Fix for STK600 32 kHz Oscillator

User Guide

Rev. 8177A-AVR-07/08

Figure 1-1. STK600 overview.

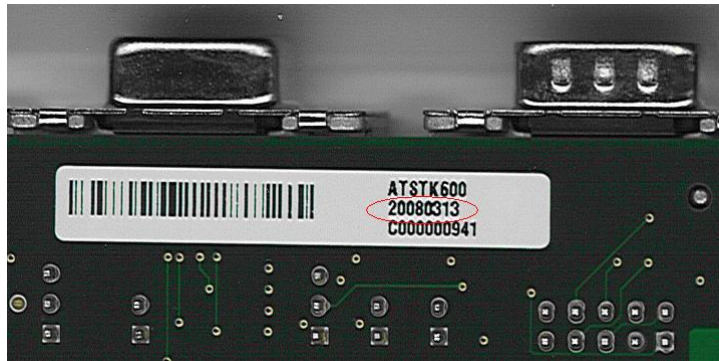
Some STK[®]600 manufactured before July 10th 2008 has a 32 kHz oscillator running on to high frequency. STK600's manufactured July 10th or later does not have this problem.

Figure 1-2. Manufacturing date.

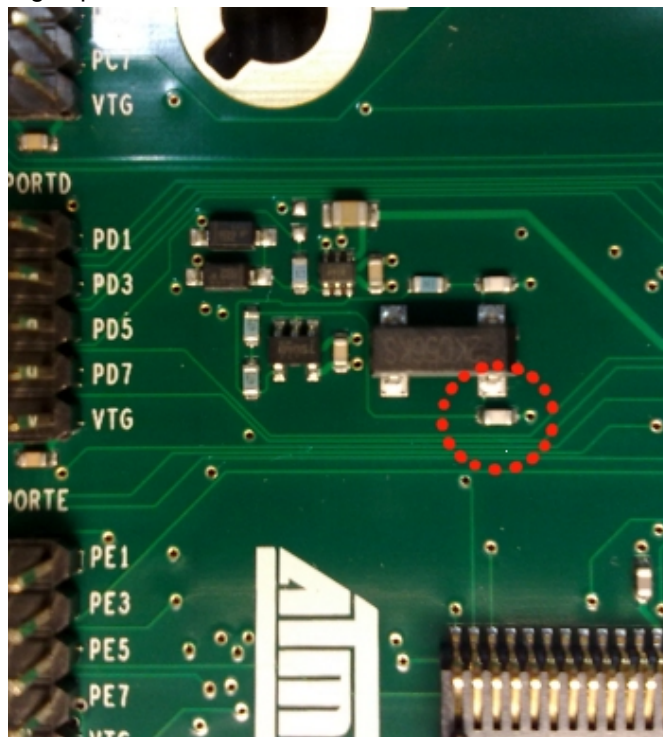
The manufacturing date for the board can be found on the sticker on the bottom side of the board.
